Wexford Joint Planning Commission

STAFF REPORT/SITE PLAN REVIEW/SPECIAL LAND USE

Applicant:	Kern, Gary 400 W. John Street Mesick, Michigan 49668
Owner(s):	SAME AS APPLICANT
Site Address, And Proposed Location	710 W. Wexford Avenue - Buckley, Michigan 49620 Parcel ID# 2411-06-2405 Hanover Township
Zoned:	COMMERCIAL / Rural Residential
Site Plan:	Attached

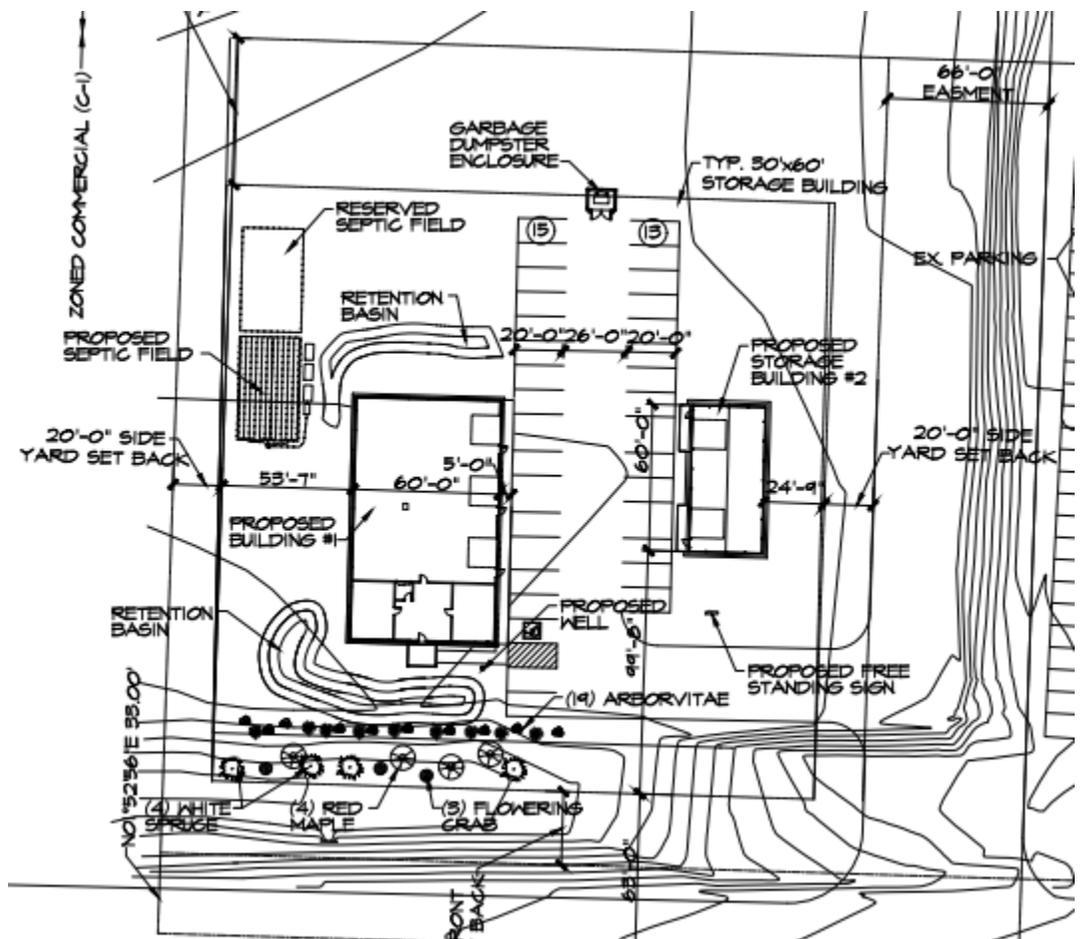
1010: **Water Supply and Sewage Facilities**- Proposed locations for both the water supply well and the septic system are shown on the site plan – subject to final design standards to be approved by the District 10 Health Department.

1013: **Surface Runoff** - Retention areas have been provided for surface water runoff.

1020: **Waste Accumulation and Outside Storage** -An enclosed dumpster has been shown on the site plan located at the rear of the subject use.

1054: **Vehicular Parking Space, Access and Lighting**-The new ‘proposed use has no specified number of parking spaces. Based upon the representations of the applicant, adequate on-site parking has been provided for employees, equipment, and any anticipated (minimal) customer load. On-site parking lot lighting shall be in compliance with Article 10, Sections 1054 and 1061

1061: **Outside Lights**-The site plan does not indicate any existing or proposed outside lighting. Any installed lighting shall comply with Article 10, Section 1061

1062: **Landscaping Standards** – Landscaping shown on site plan

Staff Comments and Recommendations: The electrical service is ‘not’ shown on the plan and will be required to be located underground in compliance with Article 94, Section 9411.B

Staff Comments and Recommendations: The ‘proposed’ well and septic system is subject to approval prior to the issuance of any Land Use (zoning) Permit that will authorize construction. The site plan shows surface water drainage and retention in lieu of any storm water management ordinance within our jurisdiction. The typography of this parcel has been utilized to direct surface water to on-site retention areas.

“Staff believes that the applicant narrative and site plan have demonstrated compliance with the purpose and intent of the zoning ordinance and it is recommended that the Site Plan of Applicant be approved.”
